Friday, January 12, 2024

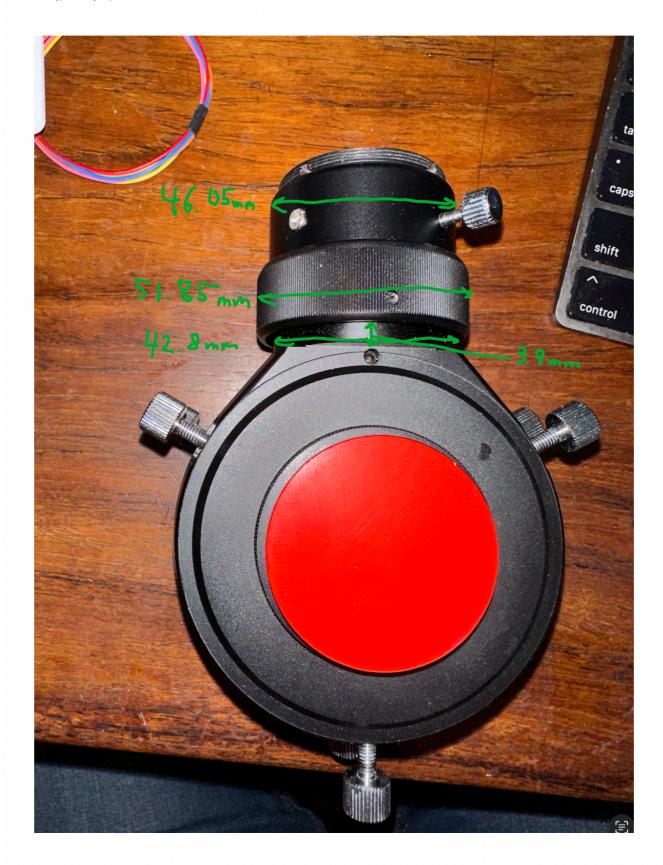
- 1. Gear inner diameter needs to match 51.85 mm diameter of Celestron OAG focus adjust ring.
- 2. Base must be extended to match change in diameter of gear.
- 3. Base Thickness around OAG tube must be less than 3.9mm.
- 1. Base Clamp diameter needs to match 42.8 mm diameter of tube at coupling point.
